ADDENDUM NO. 2

**New Premium 63 Site Loop Campground
St. Francois State Park
Bonne Terre, Missouri
PROJECT NO.: X2317-01**

August 29, 2025

SITE
PLAN

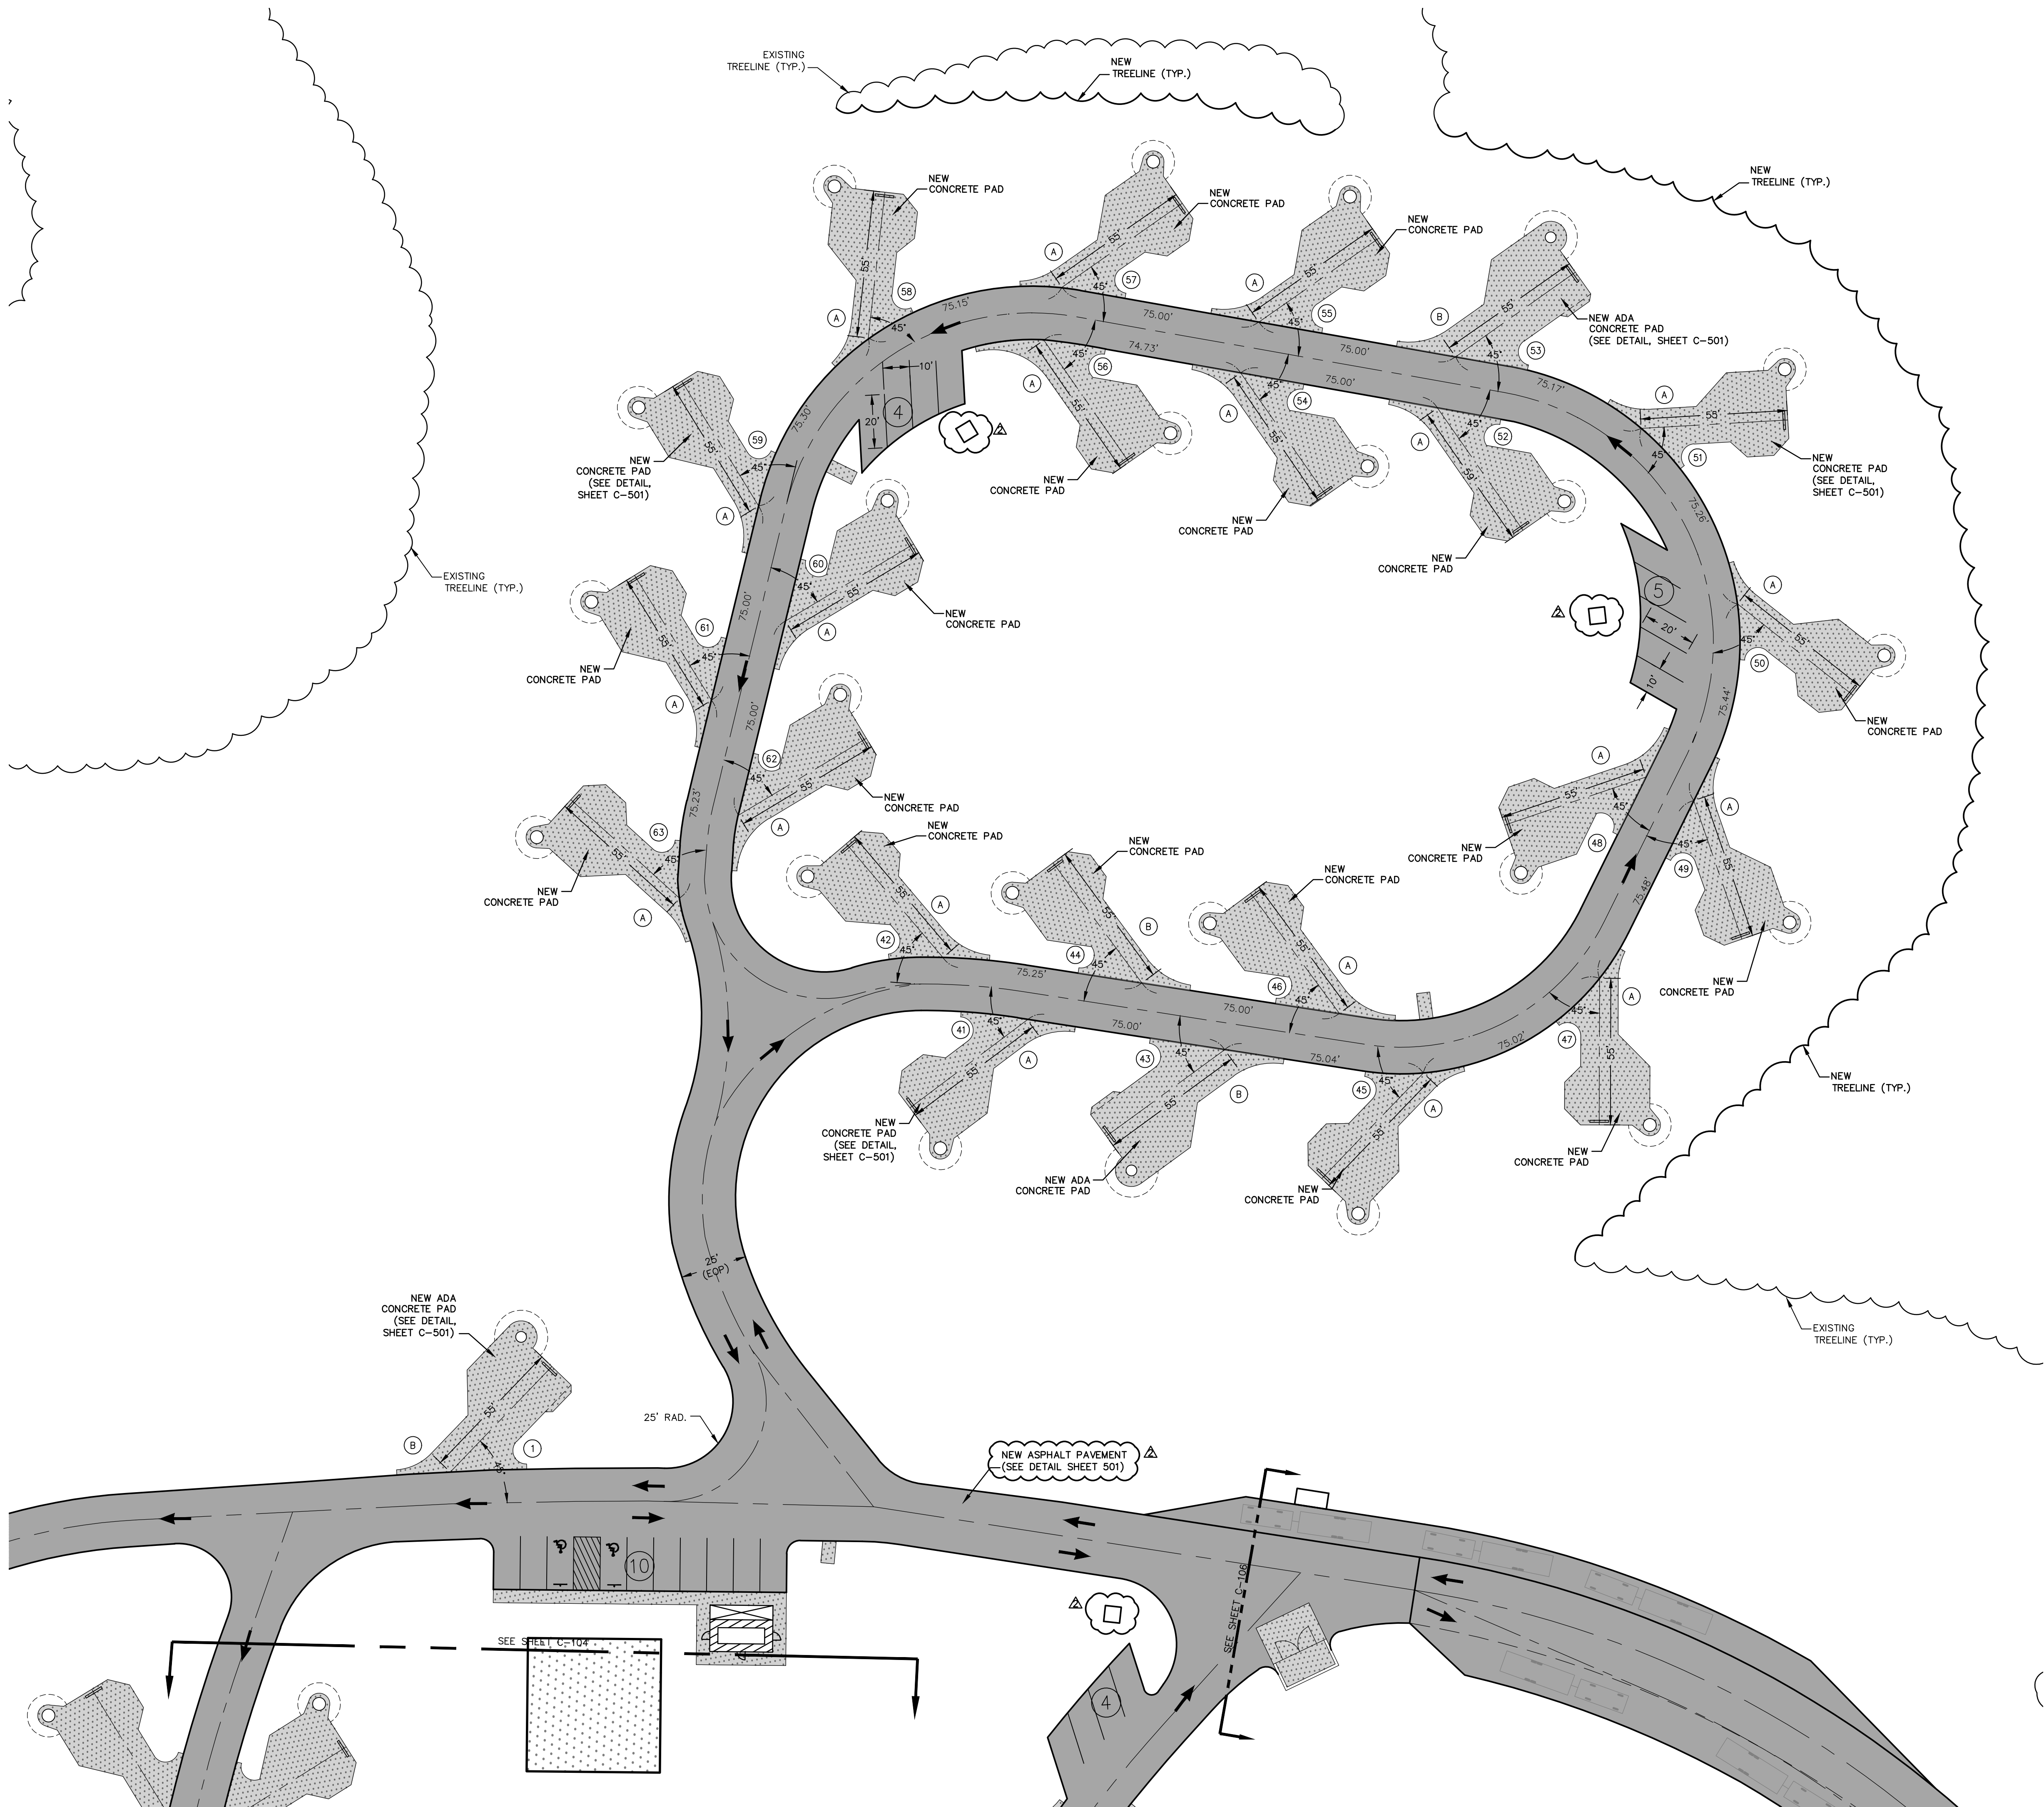
1. Removed the concrete alternate note from the plans.
2. Added and modified location of transformers.

C-107

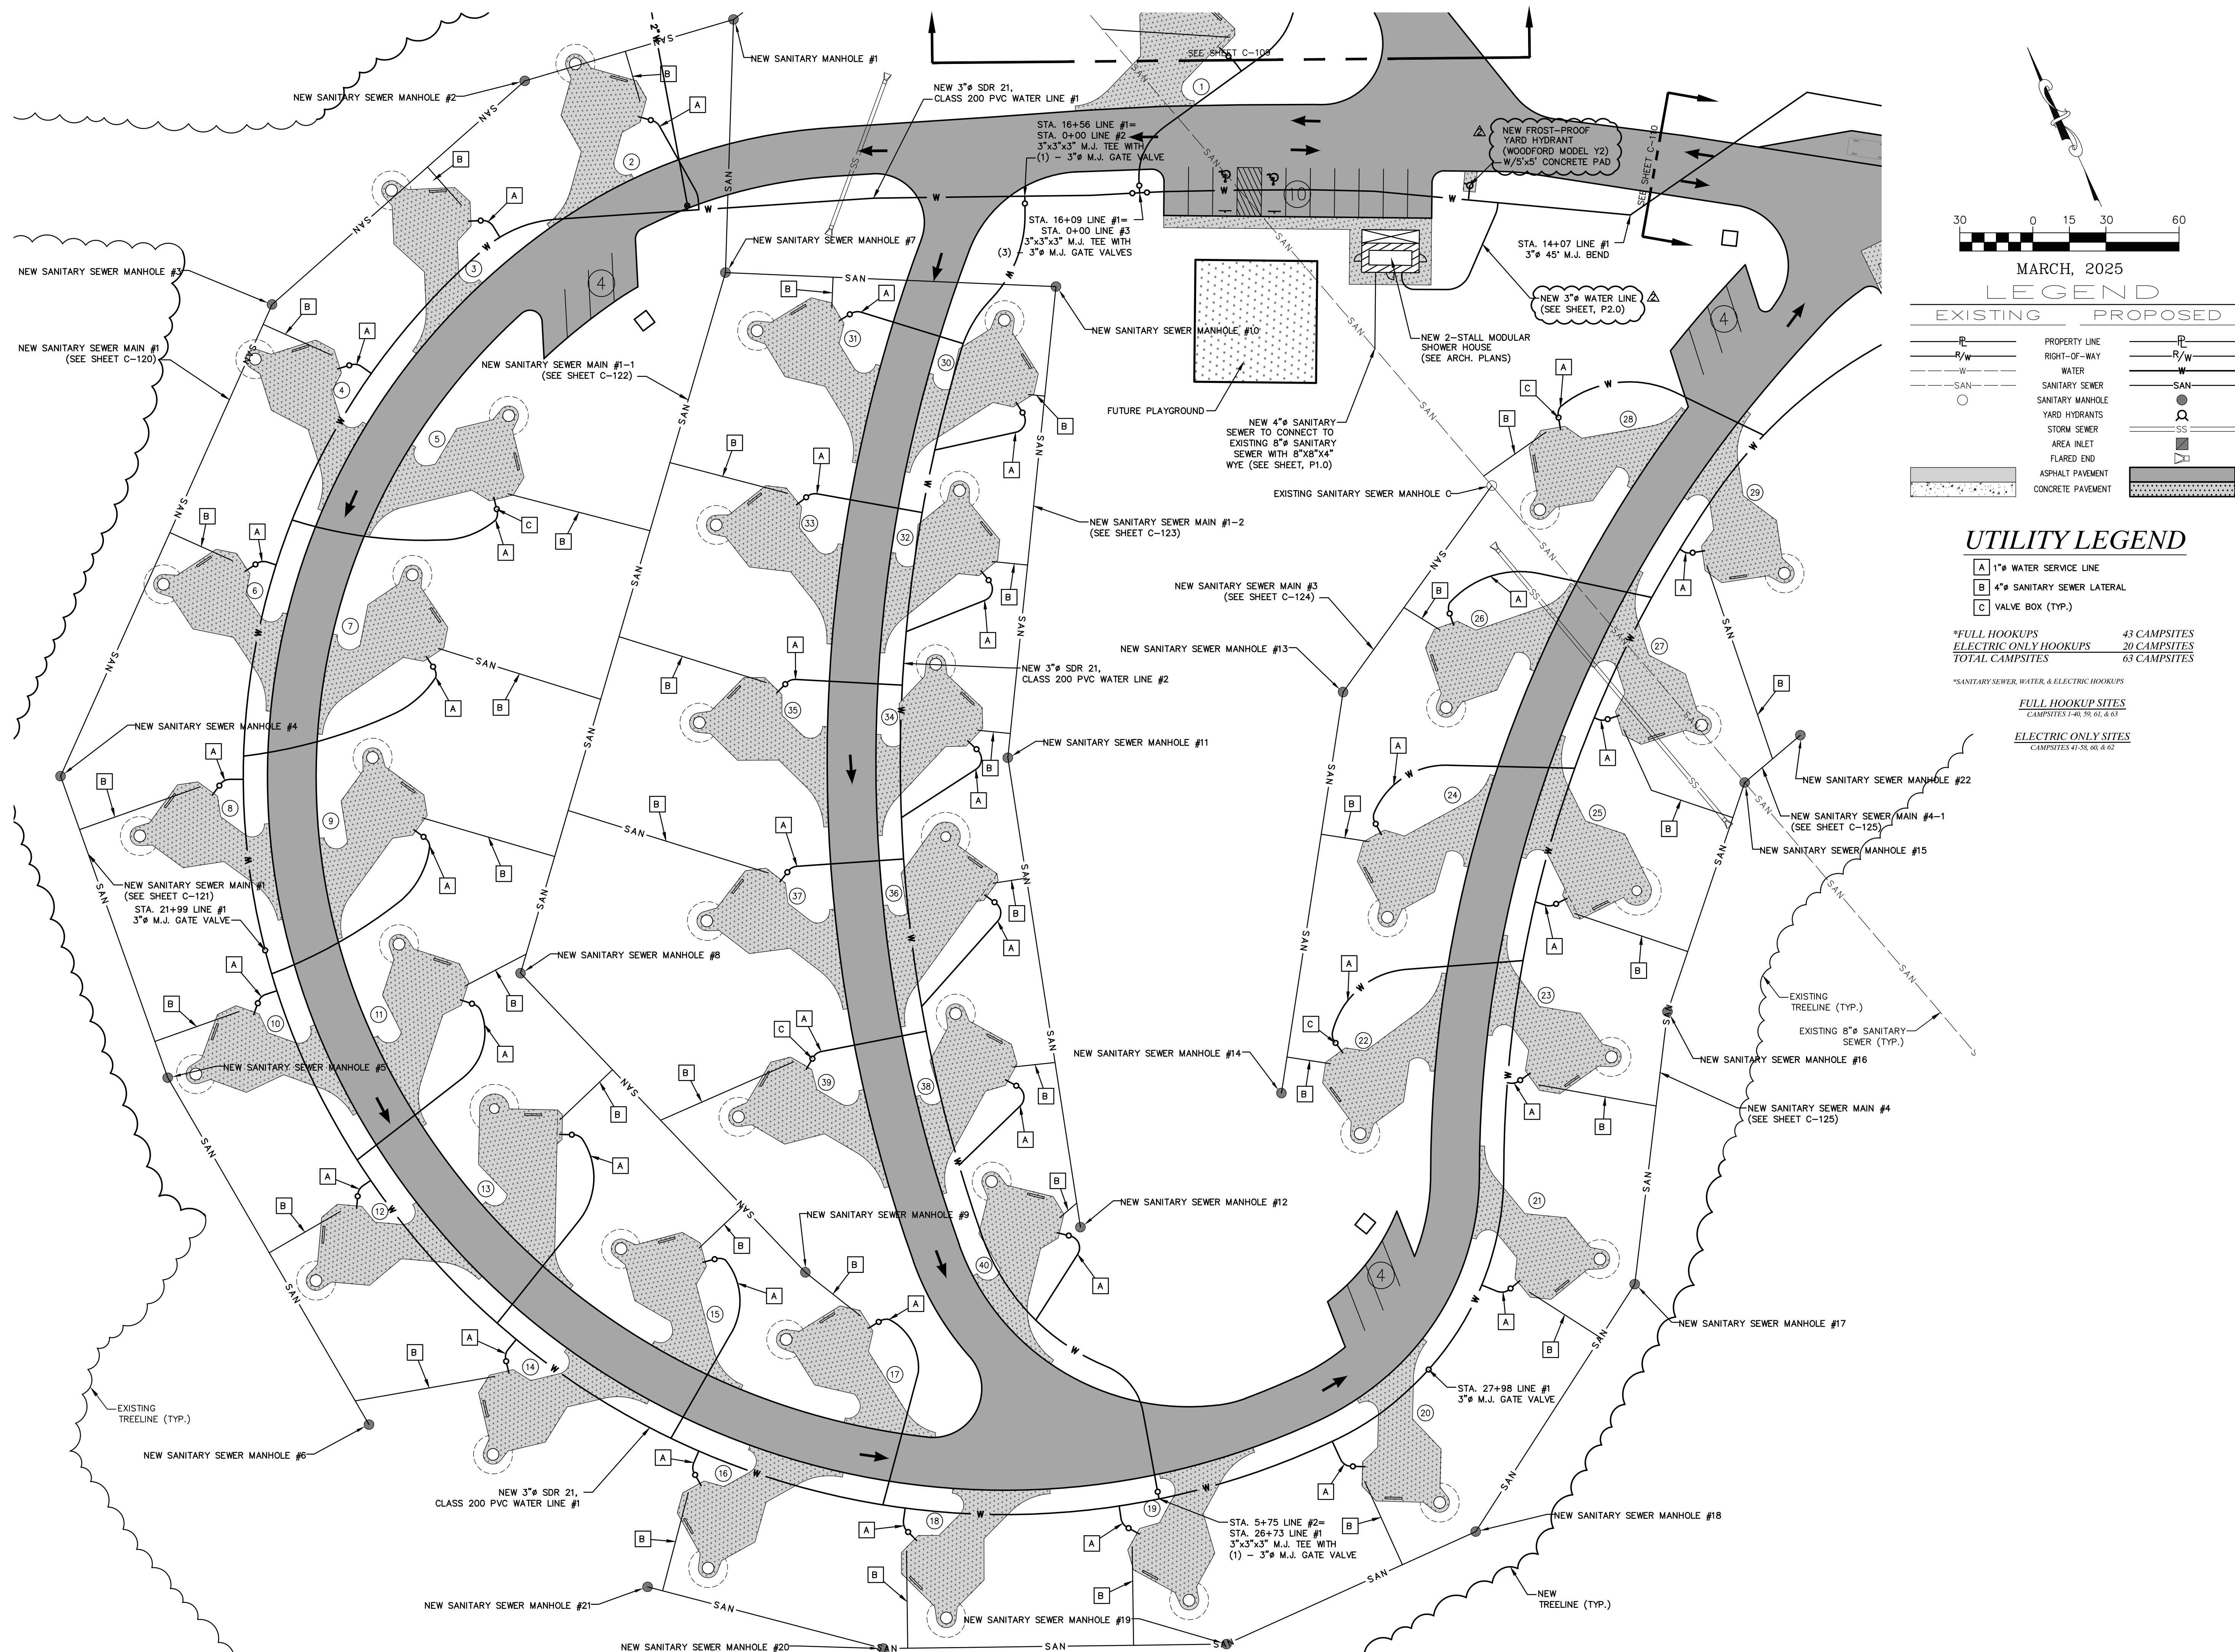
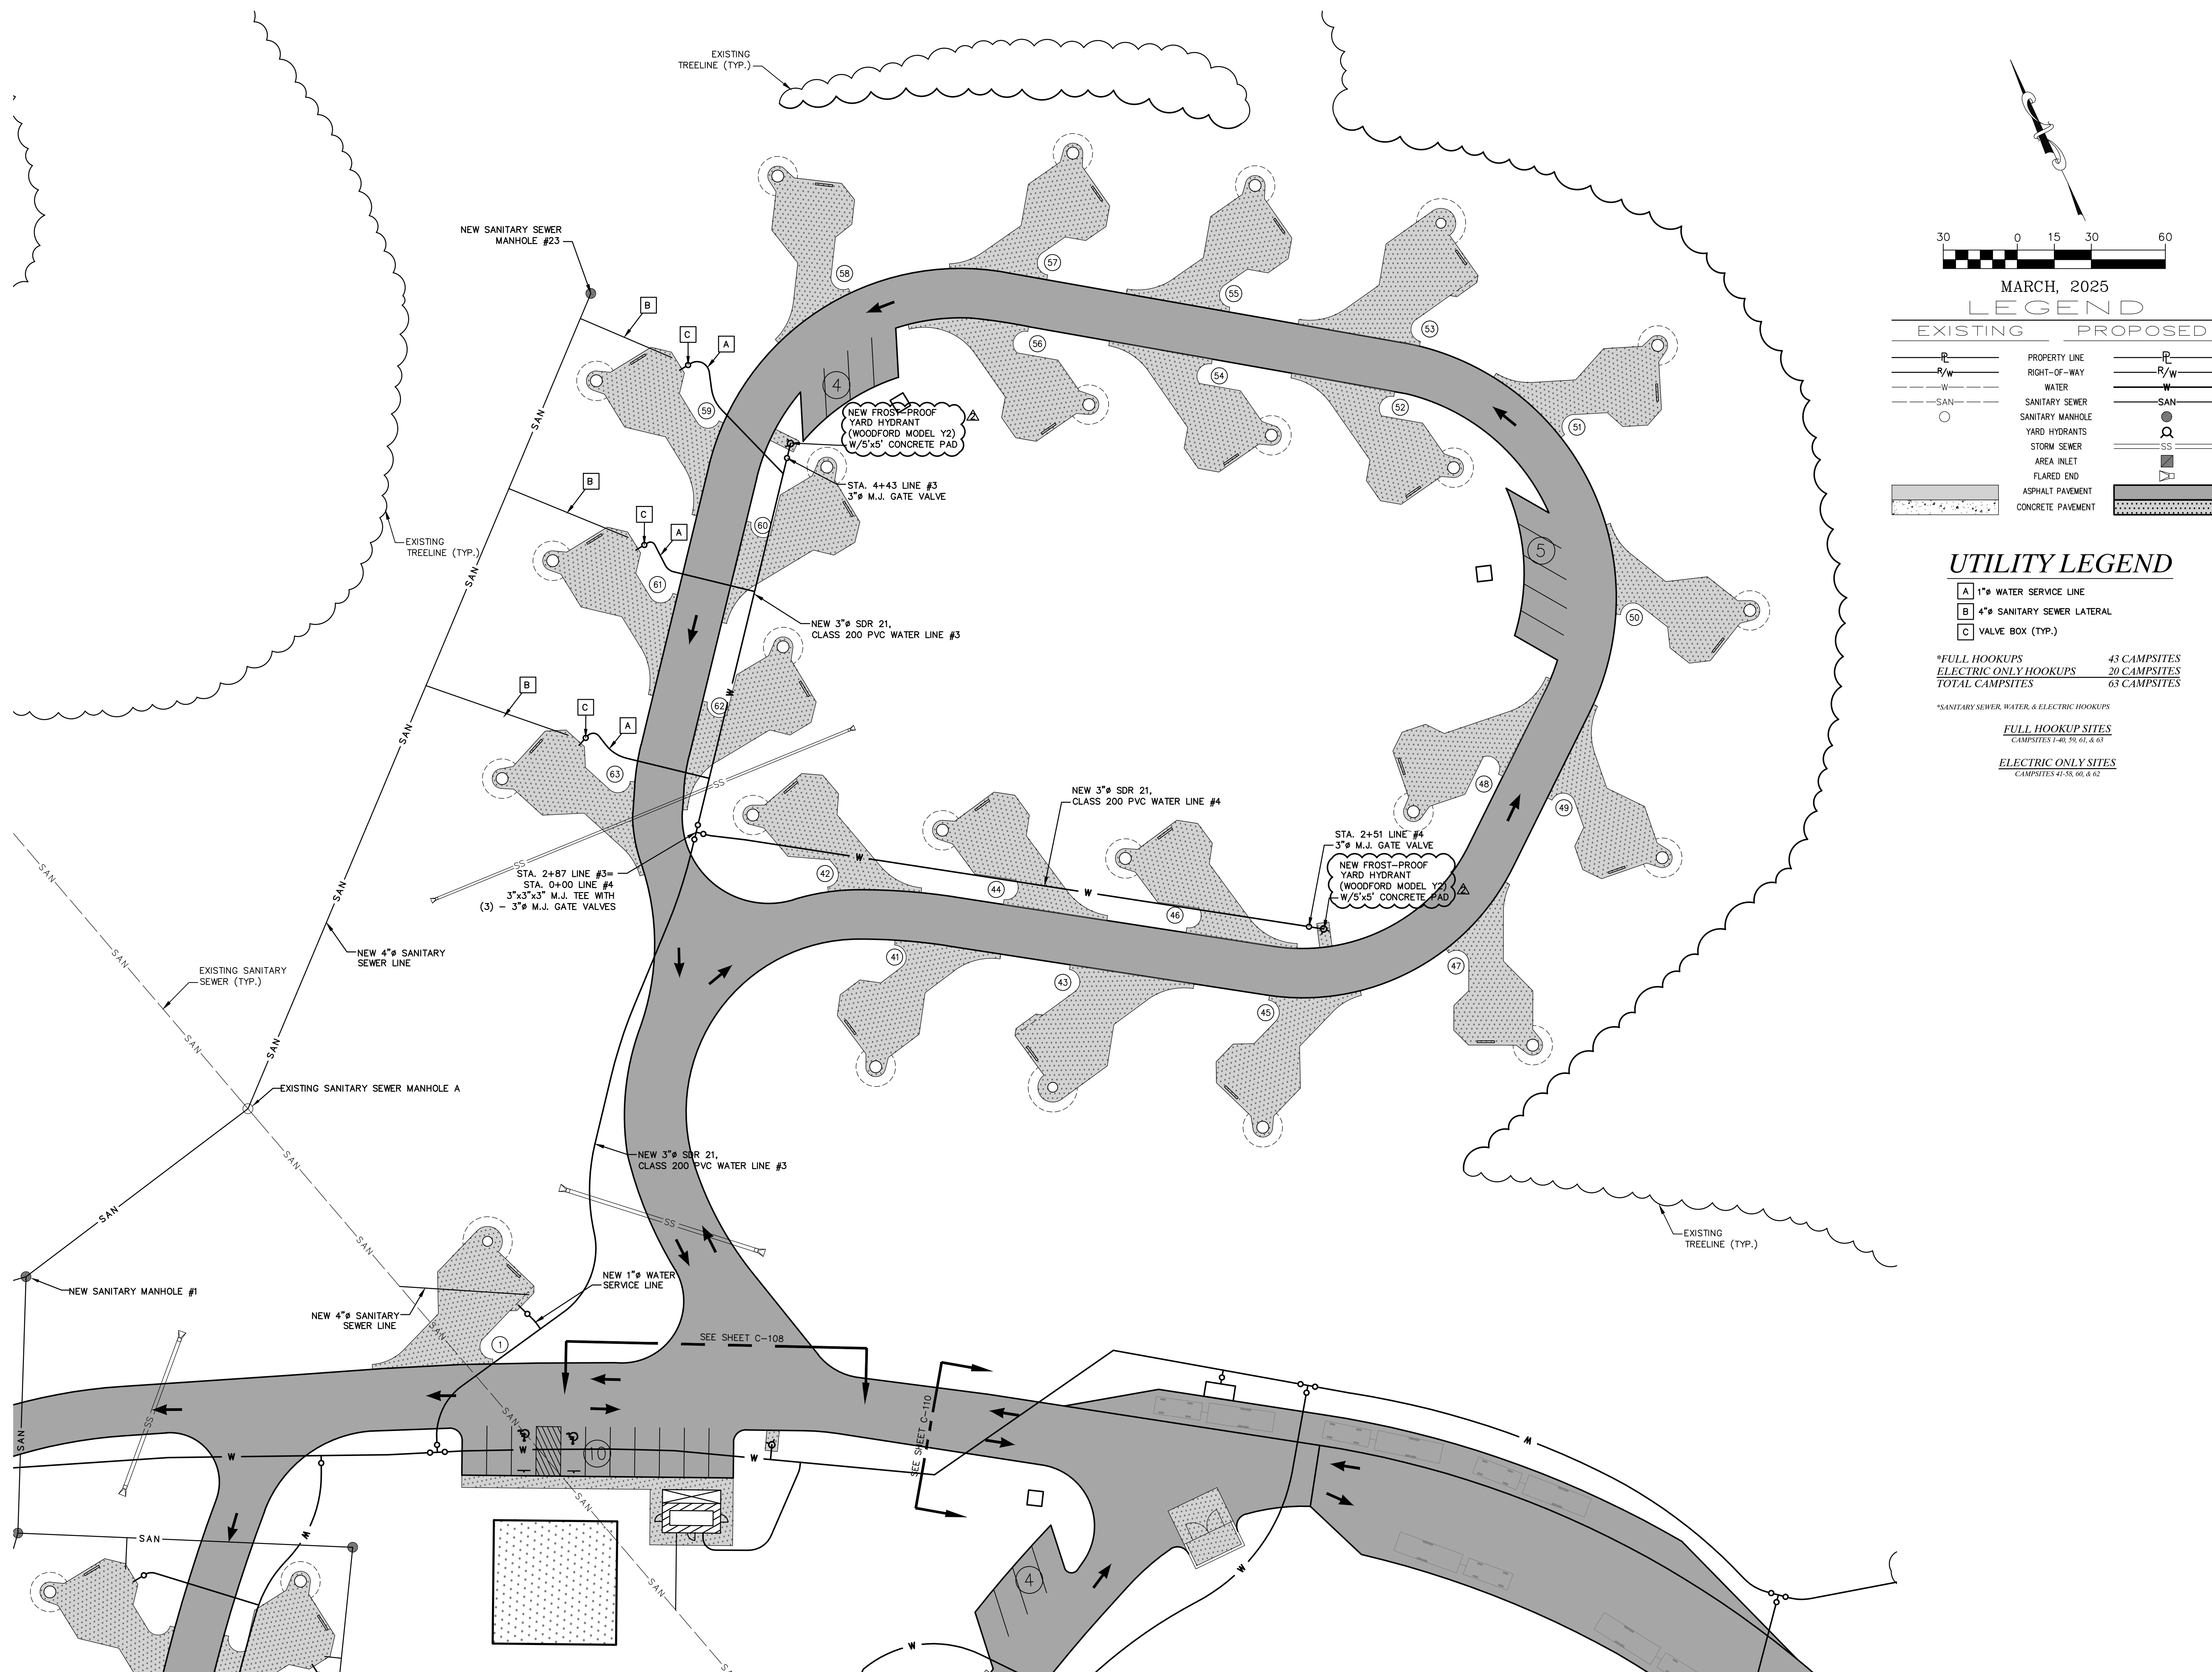
1. Added new frost proof hydrant and gate valve at end of 2-inch water line.
2. Revised electrical conduit layout and transformer locations.
3. Added tree removal for water line connection.
4. Added boring for water line under roadway.
5. Added pavement repair for water line in campground.
